**COMMUNITY DEVELOPMENT  
DEPARTMENT REPORT**

HEARING DATE: 11/21/2024  
TO: Planning & Zoning Commission  
FROM: Nick Napoli, Associate Planner  
208-884-5533  
nnapoli@meridiancity.org

SUBJECT: H-2024-0051  
WAFed at Ten Mile

LOCATION: Located at 688 N. Cliff Creek Lane in the NE ¼ of the SE ¼ of Section 10, T.3N., R1W.

**C. Site Plan (date: 9/18/2024)**

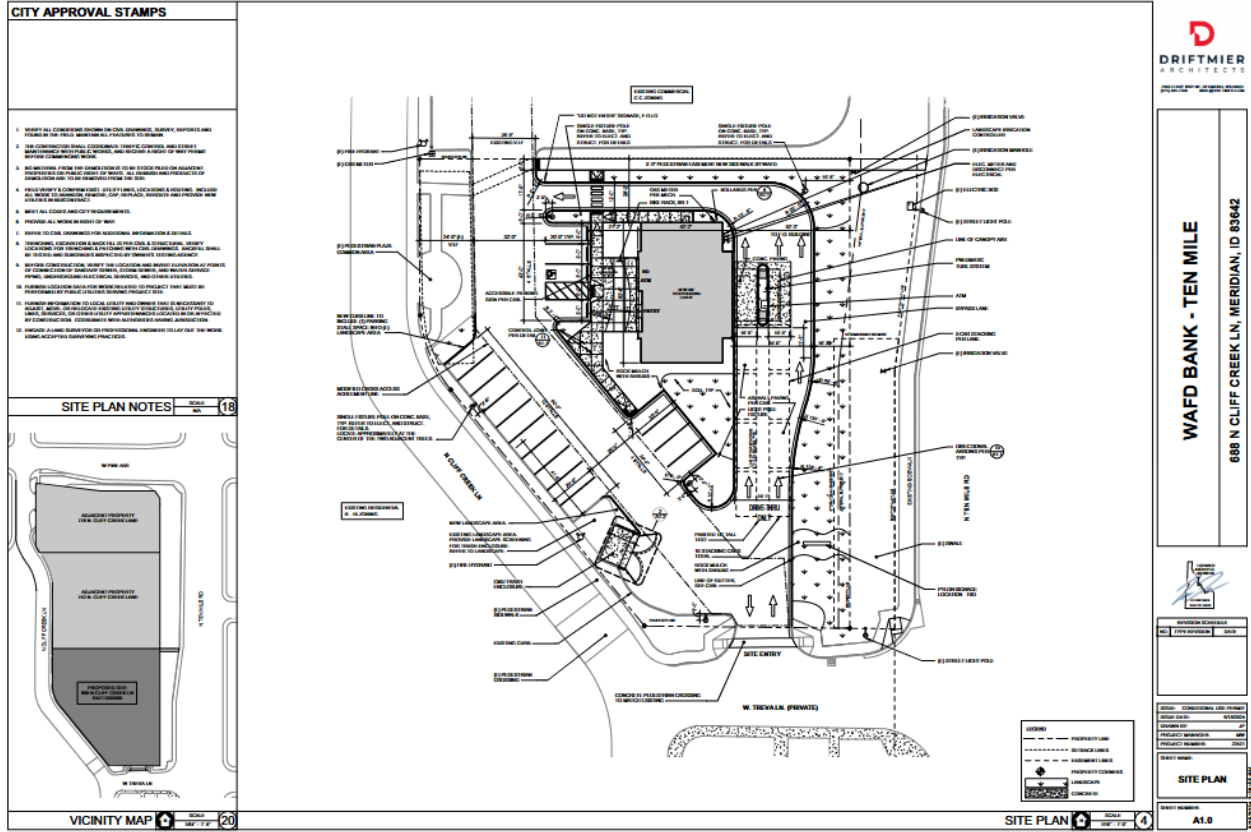
*Landscaping is required to be provided along all parking areas per the standards listed in UDC 11-3B-8. The proposed landscape plan does not meet the minimum requirements. The west landscape buffer shall be widened to 7 feet and the parking stall shall be reduced to 17 feet to provide adequate vehicle hang over. Additionally, the northern most parking stall on the west buffer shall be removed and curbing shall be extended to the next parking stall.*

A minimum of one (1) off-street parking space is required per 500 square feet of gross floor area. Based on the 2,435 square-foot building, a minimum of 5 spaces are required. *A total of 18 parking spaces are proposed exceeding the minimum requirements in the UDC. However, staff is recommending the removal of one (1) parking stall on the western buffer as it is encroaching into required open space for the neighboring multi-family development.*

The proposed plan includes a pedestrian walkway from the main walkway on the north side of the building connecting to the main entrance on the west side of the building. Where pedestrian walkways cross vehicular driving surfaces, they're required to be distinguished from the vehicular driving surface through the use of pavers, colored or scored concrete, or bricks as set forth in UDC 11-3A-19B.4. *The site/landscape plan submitted do not reflect compliance with this standard and shall be revised with the certificate of zoning compliance*

*and design review. Additionally, staff recommends moving pedestrian connections on the north portion on the site to the south to better align with the existing sidewalk to the west. This will reduce the landscaping between the pathway and drive through exit.*

2. The site plan and/or landscape plan, as applicable, shall be revised with the certificate of zoning compliance application as follows:
  - The west landscape buffer shall be widened to 7 feet and the parking stall shall be reduced to 17 feet to provide adequate vehicle hangover.

- A tree shall be depicted in the planter island to the northwest of the trash enclosure.
  - Delineate the pedestrian connection through the drive aisle with the use of pavers or stamped and colored concrete.

- Shift the northern pedestrian connection to the south to better align with the existing pedestrian connection on the western portion of the site.
  - Remove the northernmost parking stall on the western landscape buffer and provide landscaping in lieu of the stall per the recorded development agreement.

**D. Landscape Plan (date: 8/23/2024)**

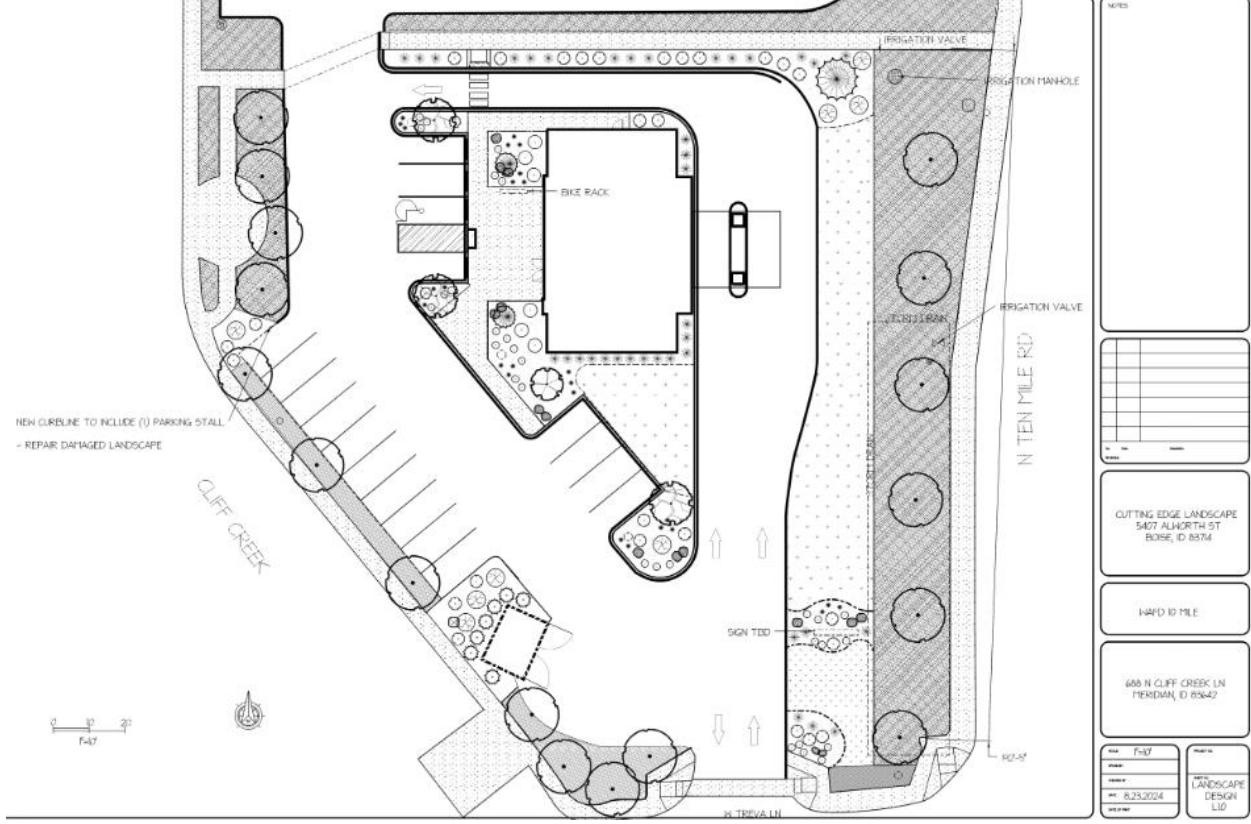
*A 25-foot wide street buffer is required along N. Ten Mile Road, an arterial road. This landscape buffer shall be landscaped per the standards in UDC 11-3B-7C. The proposed landscaping does not meet the minimum requirements. Lawn and other grasses shall not comprise of more the 65 percent of the vegetated coverage. This shall be revised with the submittal of certificate of zoning compliance and design review.*

- Revise the eastern landscape buffer to incorporate a variety of vegetation coverage as lawn and other grasses shall not comprise of more the 65 percent of the vegetated coverage.
